Recommend variance from statutory setback distance of 100 feet between well and septic leachfield for APN 006-160-034, Christian Gallery and Lucy Snyder, based upon uniqueness of property regarding geology and hydrology.

TO: Board of Supervisors  
FROM: Charles B. Mosher, M.D., MPH, Health Officer  
SUBJECT: Variance request on Gallery property, APN 006-160-034

Re: Mariposa County Assessor's Parcel 006-160-034, aka 1248 Yosemite Way, Foresta.

GEOLOGIC CROSS-SECTION  
 MARIPOSA COUNTY APN: 006-160-034

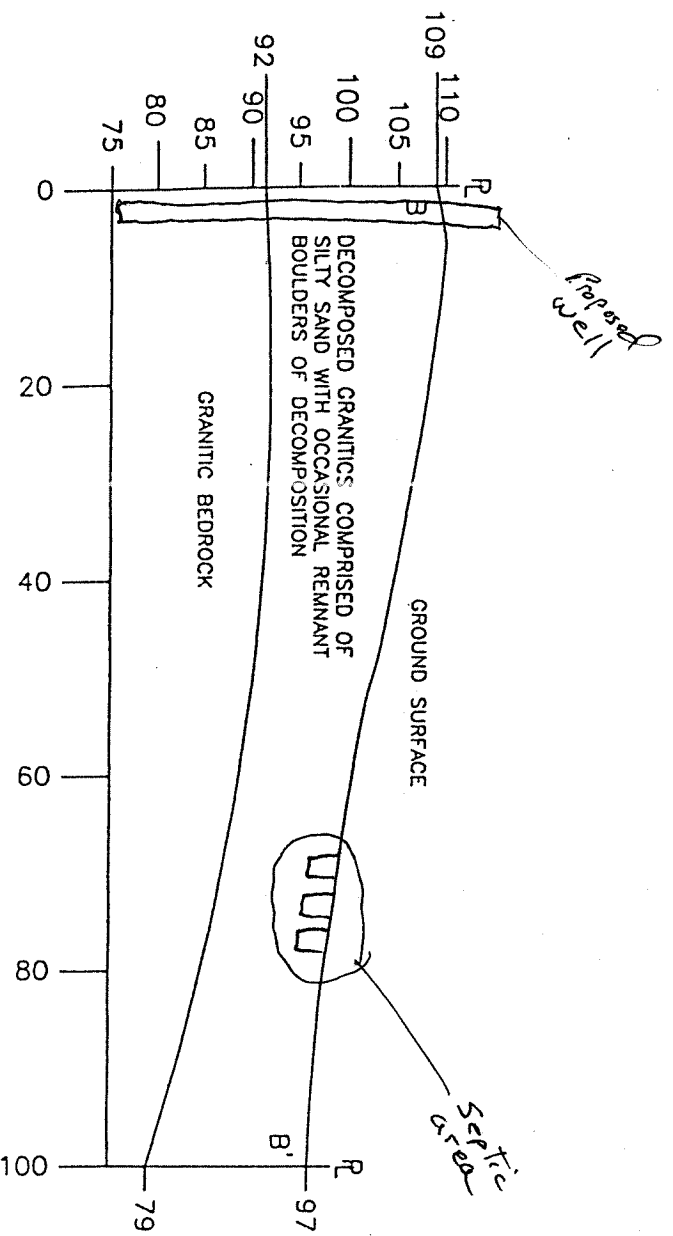
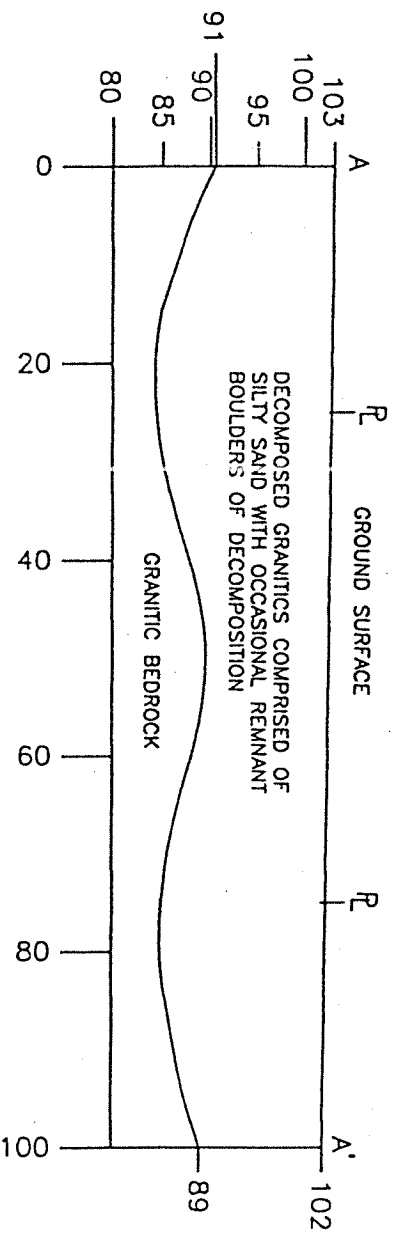
A geologic cross section is presented as Figure One. This cross section, which represents a pictorial "slice" of the earth between the northern and the southern property lines, has been compiled based on (1) surface geologic mapping, (2) the results of the Health Department trenching, and (3) seismic profiling. The resultant picture is one of several feet of loam topsoil underlain by decomposed granitics, and finally granitic bedrock.
